**Paycor Stadium Southeast & Southwest VT Escalator Towers
Bid Package 2: Steel, Demo & Concrete
ITB#033-26
Addendum 3**

May 6, 2026

SECTOR 4 - LEVEL 350 RAMP

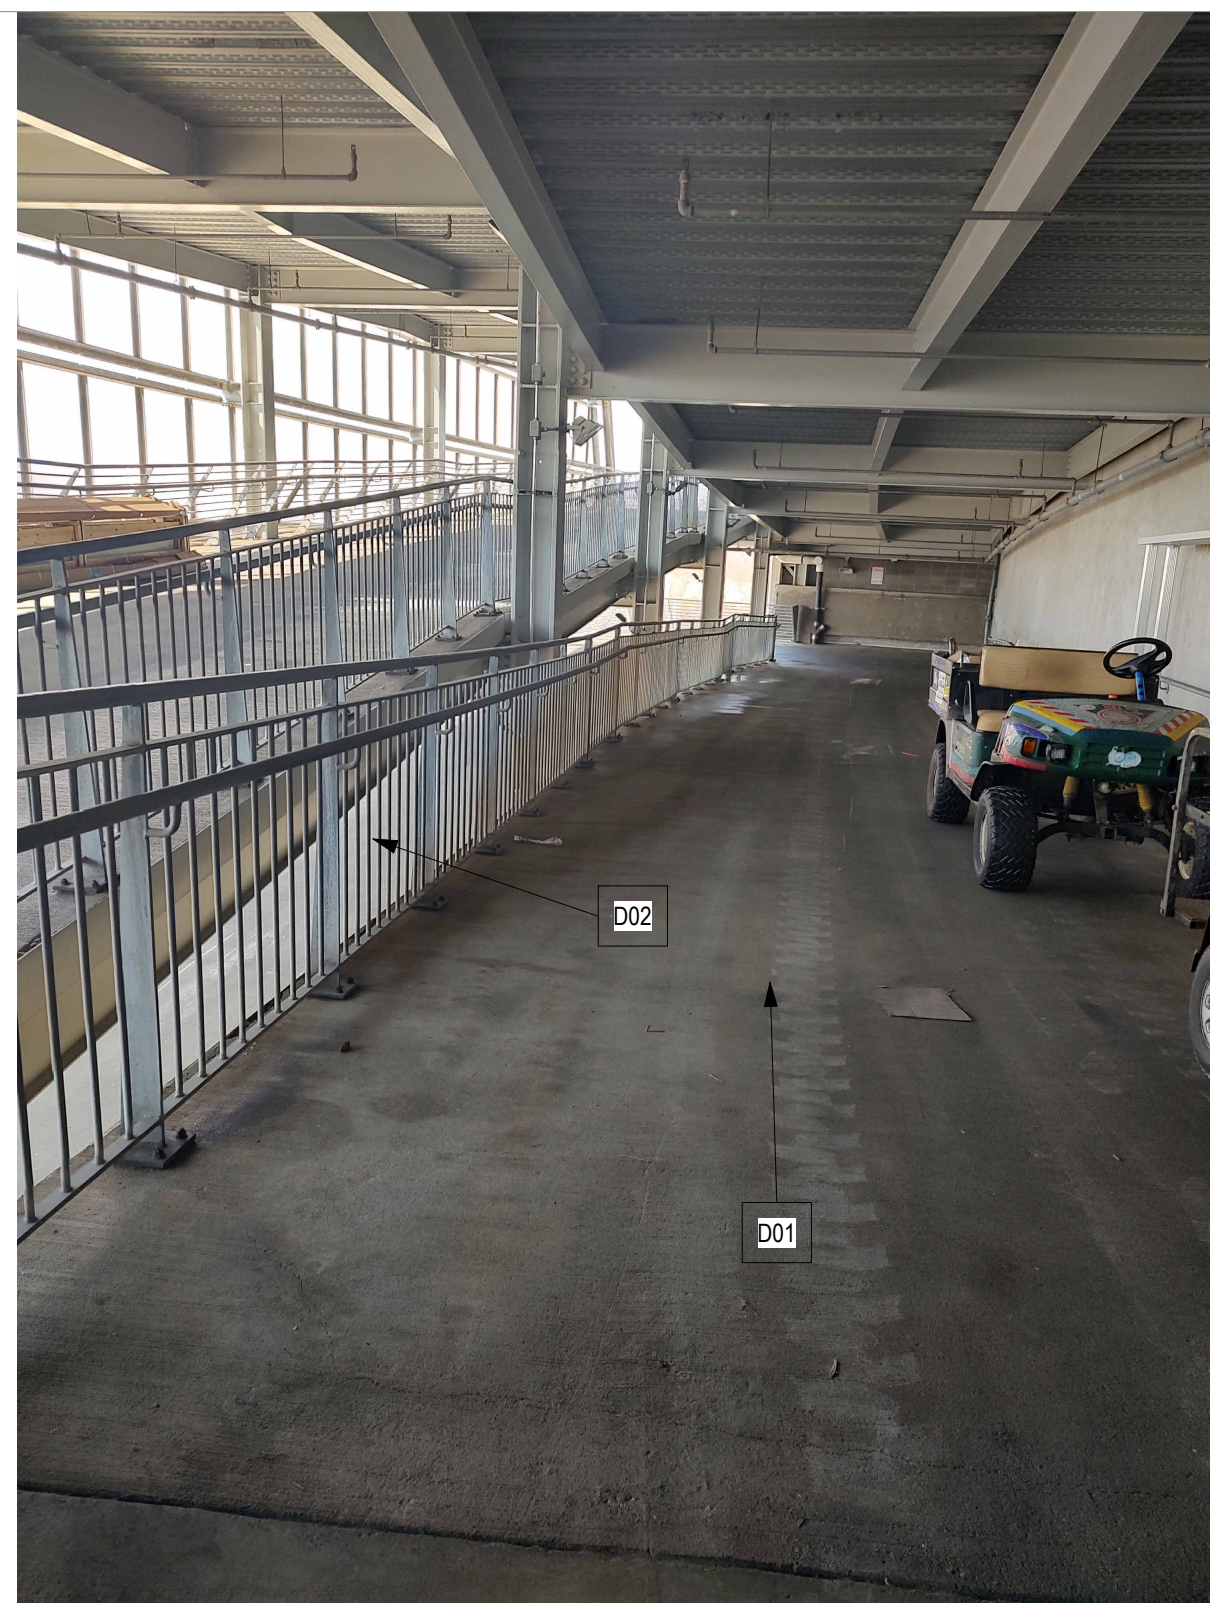
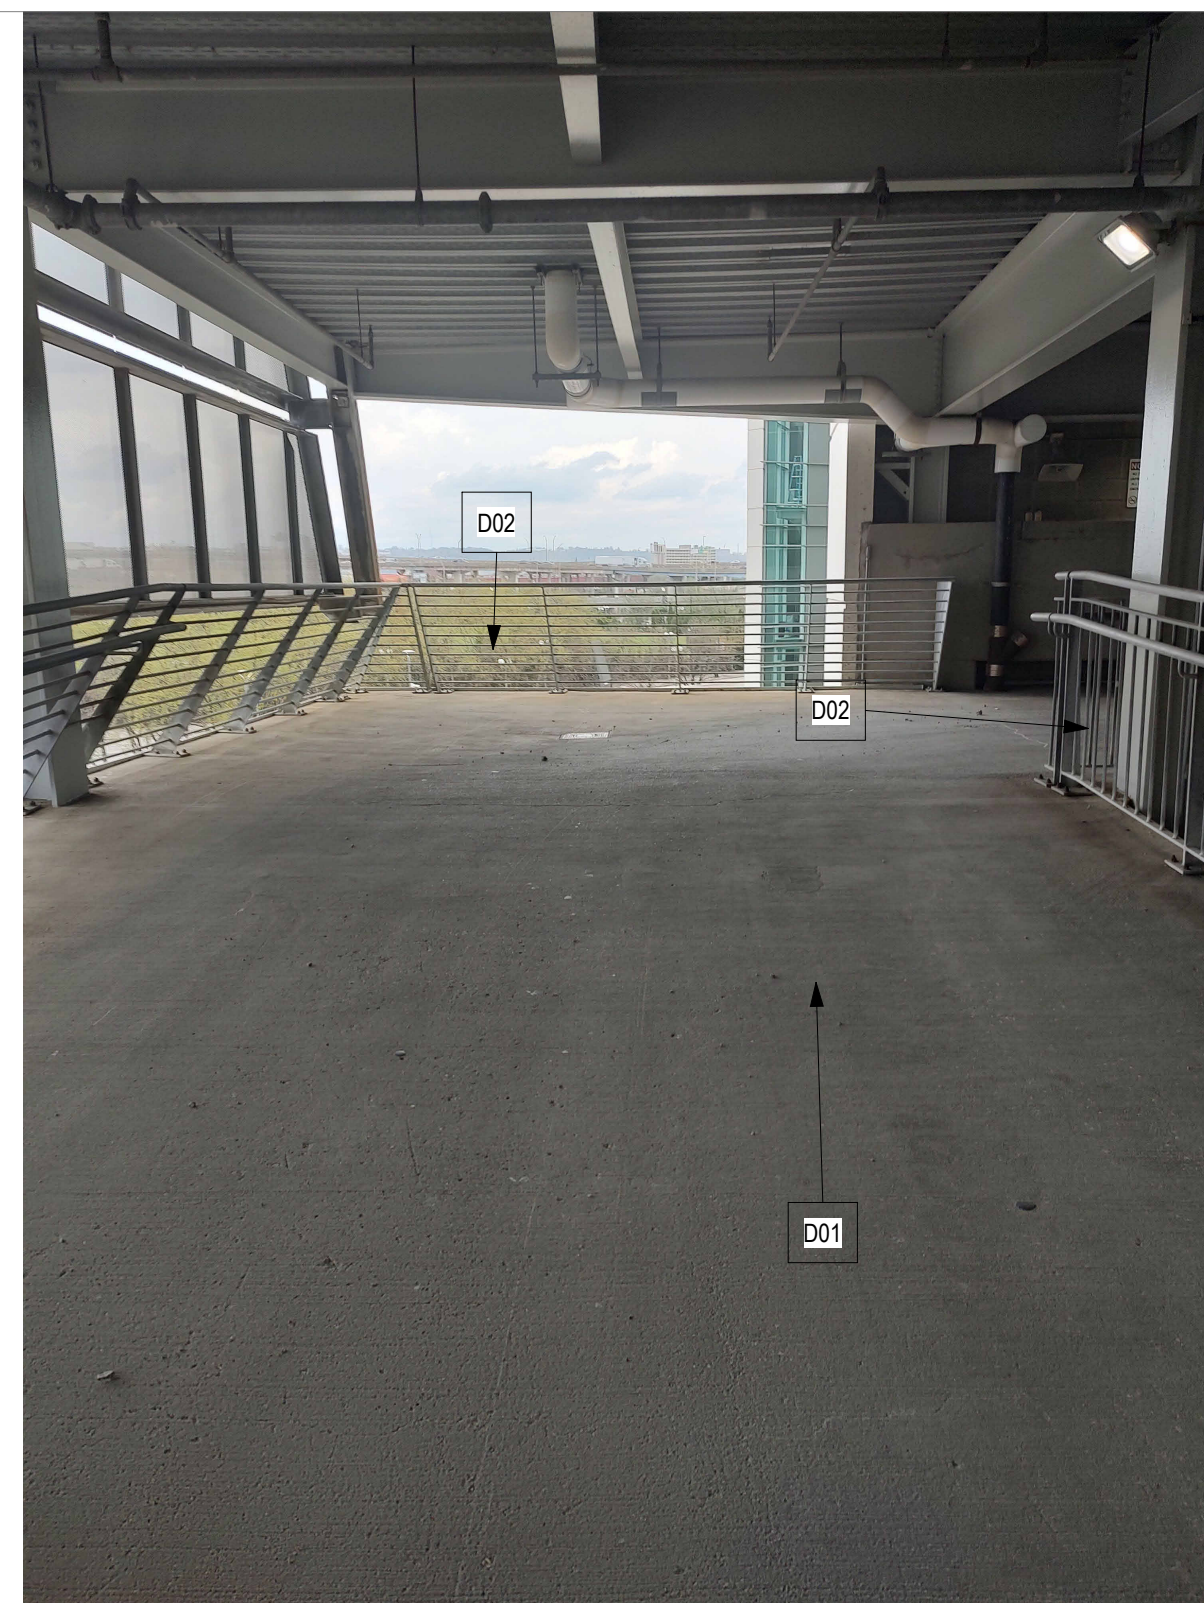
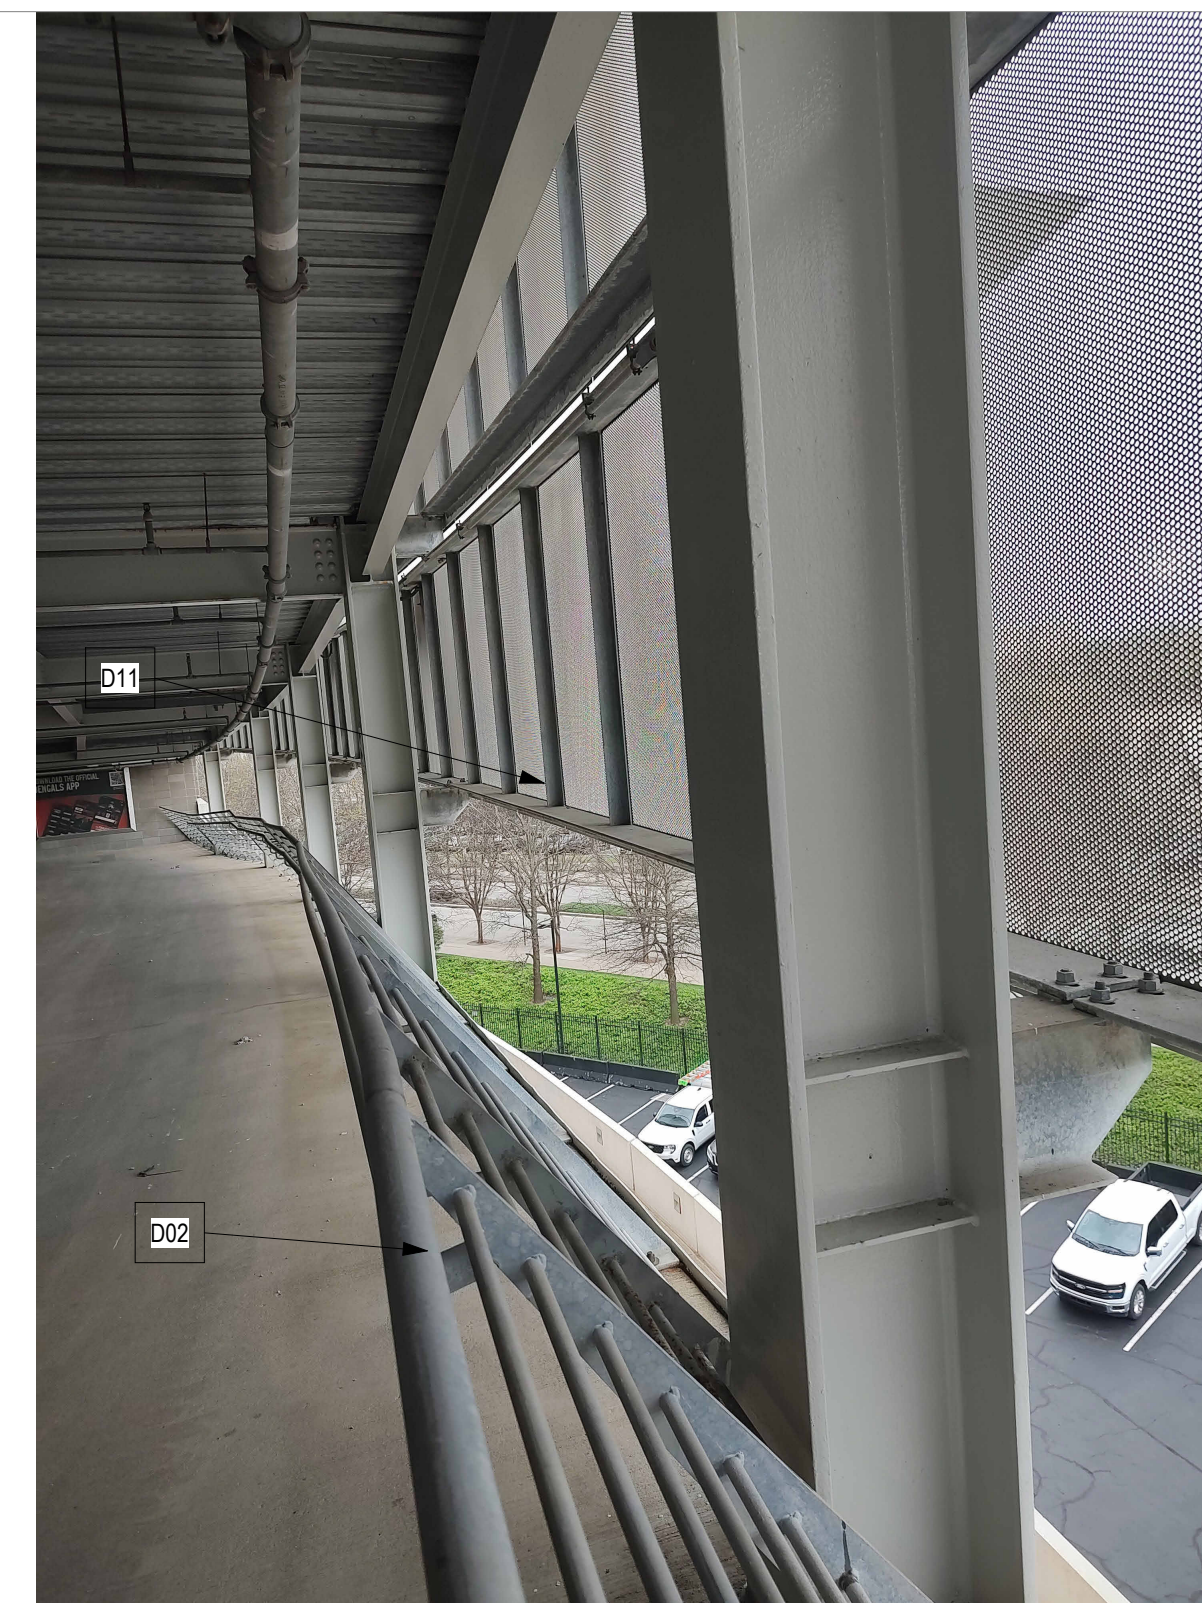
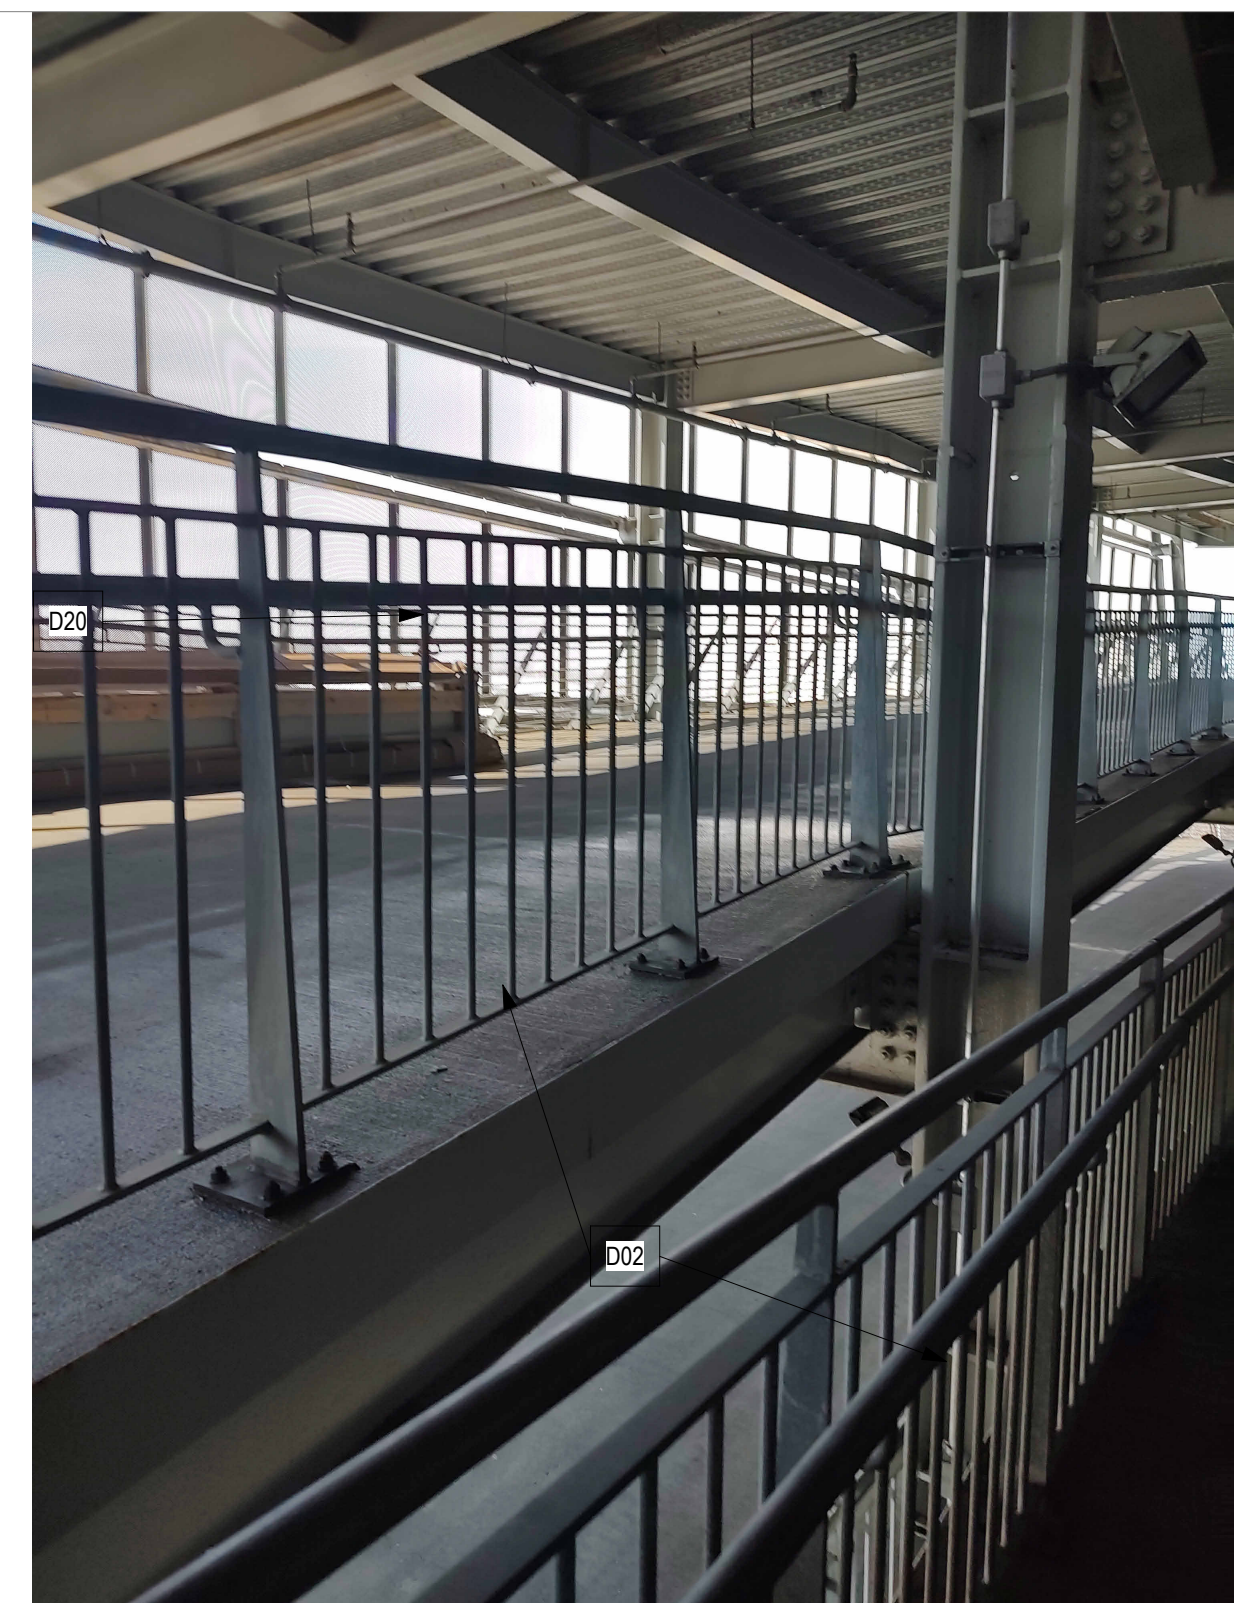
AD-101	New sheet with existing photos.
AD-103.4	Sector 4 – Level 400, 500 North wall to remain with limited demolition to remove existing Club stair.
AD-104.4	Sector 4 – Level 600 North wall to remain
AD-211.4	Sector 4 – Demolition Section & Elevation North wall to remain with limited demolition to remove existing Club stair.
S-103	Refer to sheet for clouded revisions
	Framing revisions
	S-104
	Refer to sheet for clouded revisions
	Framing revisions
S-105	Refer to sheet for clouded revisions
	Framing revisions
	Added section cuts
S-106	Refer to sheet for clouded revisions
	Framing revisions
S-108
